# COMAL COUNTY

## License to Operate On-Site Sewage Treatment and Disposal Facility

Issued This Date: **12/11/2023** Permit Number: **115771**

Location Description: 589 WINDMILL RIDGE DR  
BLANCO, TX 78606

SCALE 1" = 100'

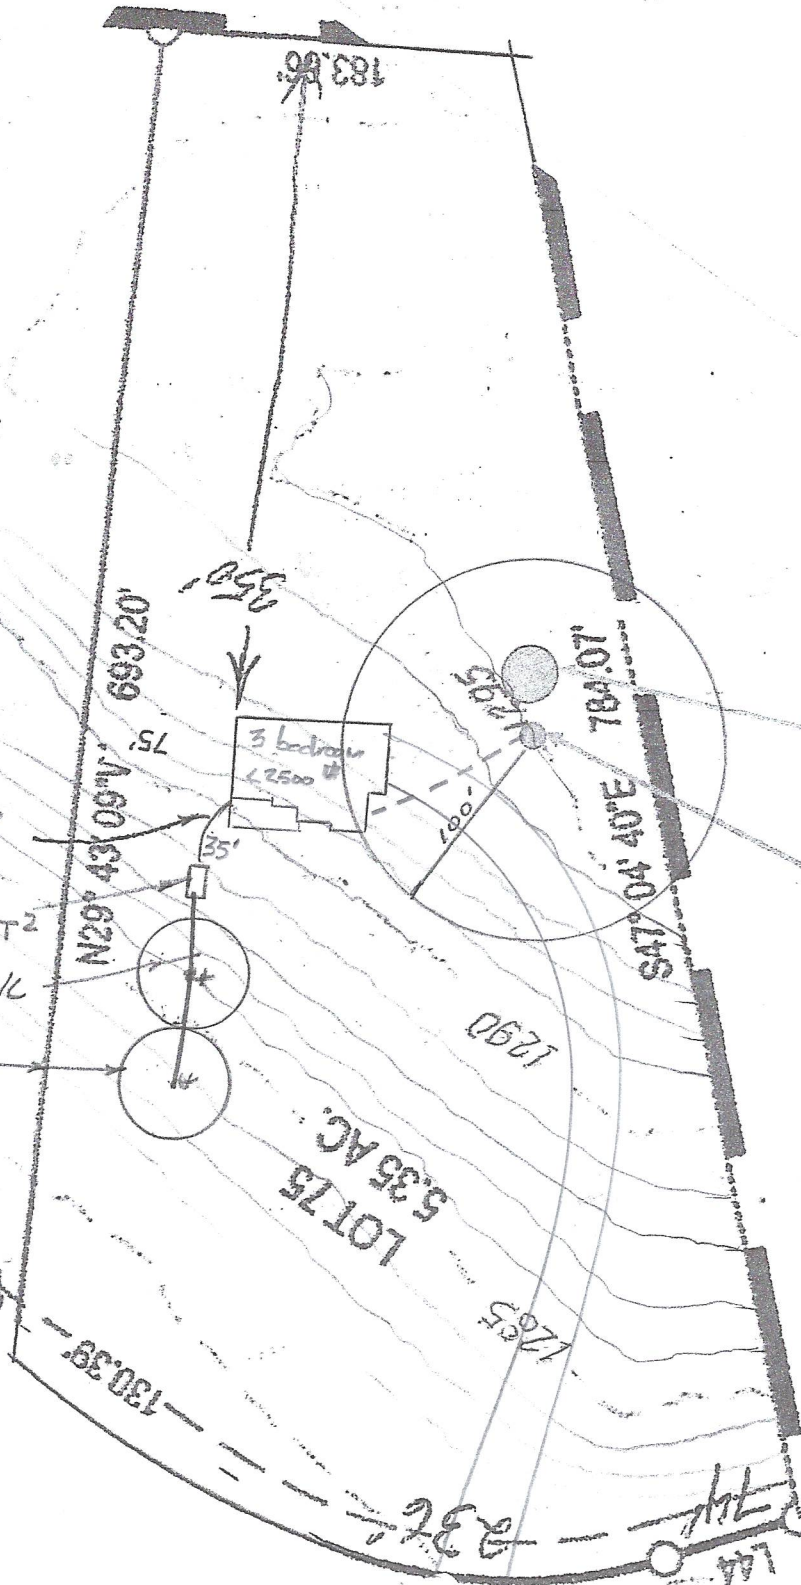
1. This property is located over the Edwards Contributing Zone. The designer must revise the 2<sup>nd</sup> page of the permit application accordingly.
2. The designer must also:
  - ✓ Identify the structure on the design.
  - ✓ Show the location of the water supply line on the design.
  - ✓ Identify the separation distance from the house to ATU.
  - ✓ Remove reference indicating a 1000 gallon septic tank is required and revise to ATU requirements on page 1 of 3.
  - ✓ Show the location of the driveway on the design.
    - f. Complete the site and soil evaluation information as per TCEQ requirements and show test hole locations on the design.
  - ✓ The designer must sign the tank detail and indicate how many gallons of reserve capacity is provided.
3. Revise above as needed and resubmit.
